**City of Glendale  
Community Development Department  
Design Review Staff Report – Single Family**

<b>Meeting/Decision Date:</b> July 26, 2019	<b>Address:</b> 4526 New York Avenue
<b>Review Authority:</b> <input type="checkbox"/> DRB <input checked="" type="checkbox"/> ADR <input type="checkbox"/> HPC <input type="checkbox"/> CC	<b>APN:</b> 5602-020-013
<b>Case Number:</b> PDR 1905877	<b>Applicant:</b> Rita Noravian
<b>Prepared By:</b> Betty Barberena, Associate Planner	<b>Owner:</b> Gary Myers

The applicant is proposing a one-story addition totaling 595 square-feet to the rear of an existing one-story, 1,244 square-foot single-family house (built in 1948) on a 8,315 square-foot corner lot located in the R1 (Residential) Zone, FAR District II. The proposed addition will comply with all current Zoning Code requirements and design guidelines.

PROPOSED FLOOR PLAN

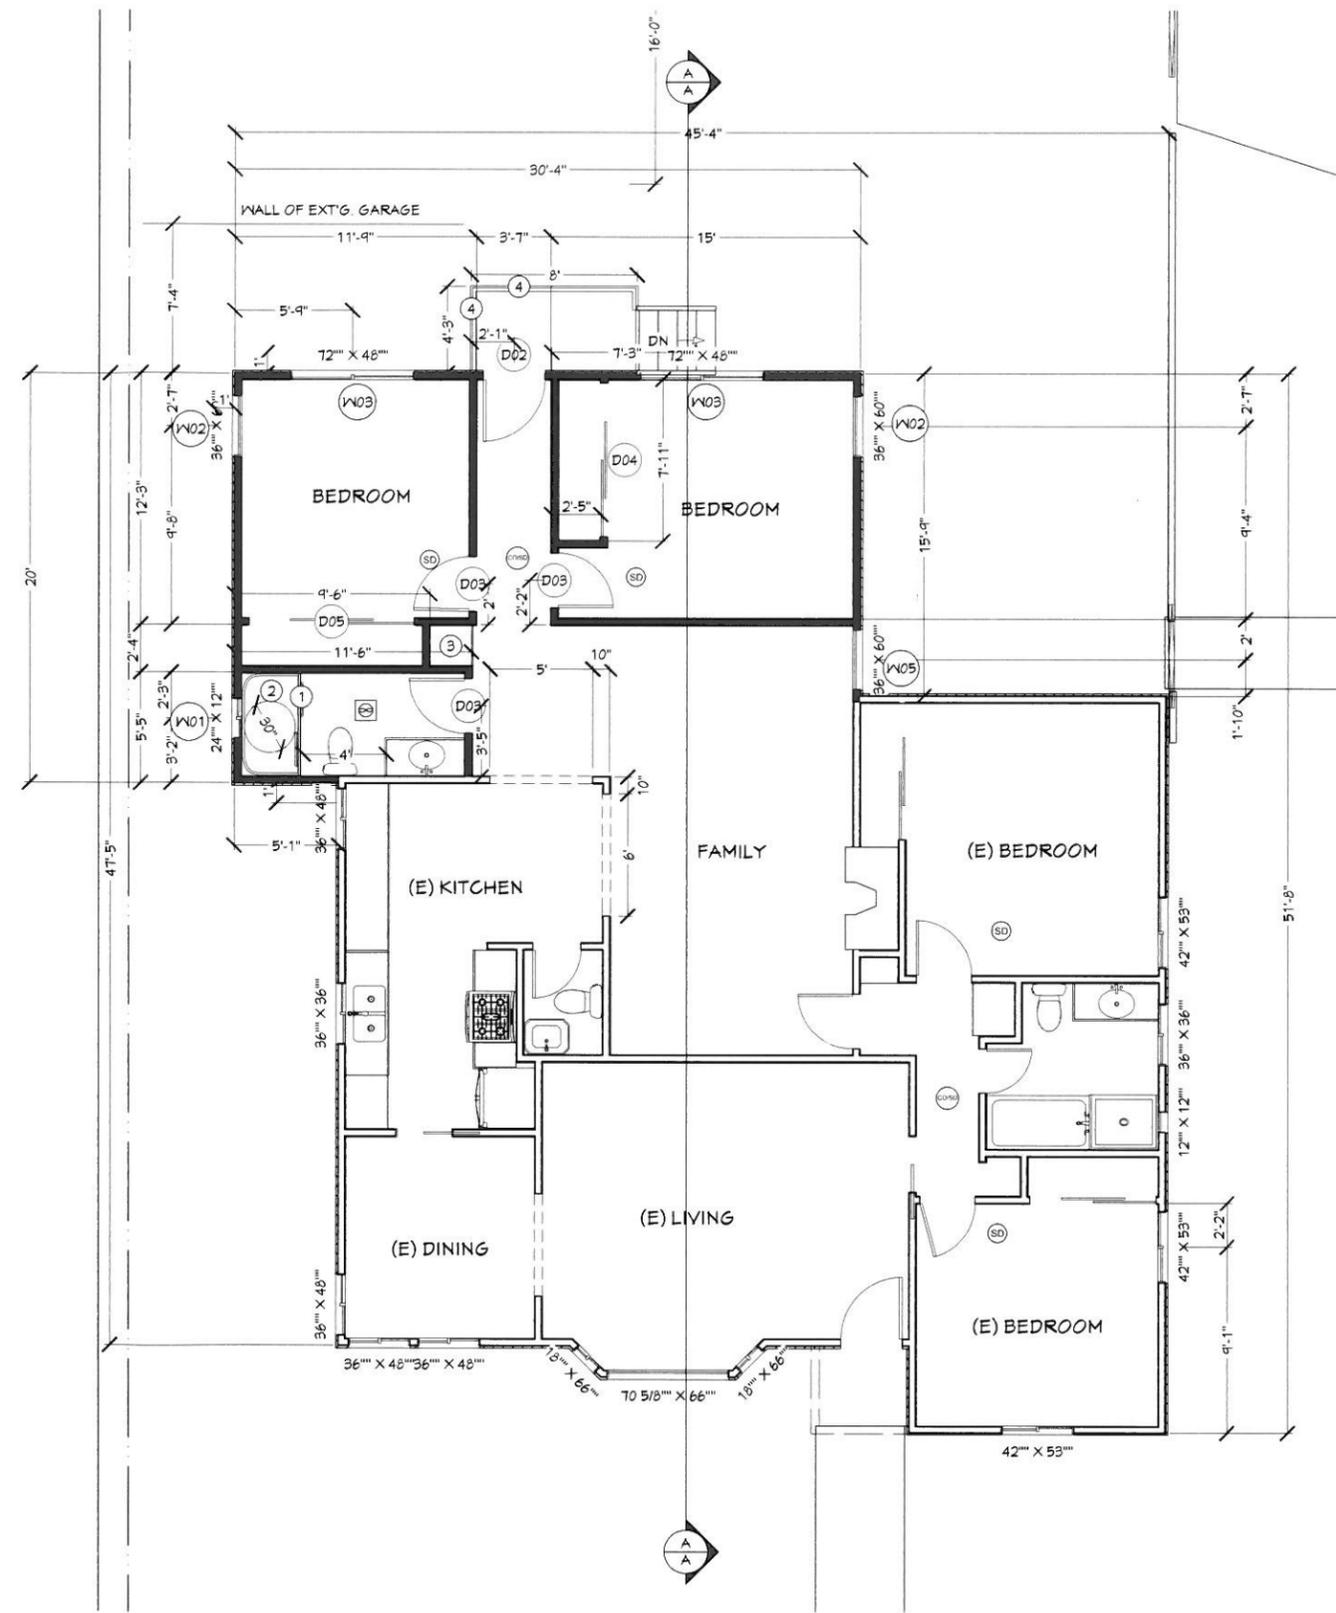
- The placements of the new addition's windows avoid facing adjacent properties' windows to maximize privacy.
- The window placement on the north side of the addition in relation to the placement of the adjacent property windows is unclear. Therefore, to maximize privacy, staff is recommending a condition of approval that requires placing this specific window where it avoids facing adjacent property windows.

1. That the new window sills will be made of material and color matching the sills of the existing windows.
2. That the placement of the window on the north side of the addition avoid facing adjacent property windows.
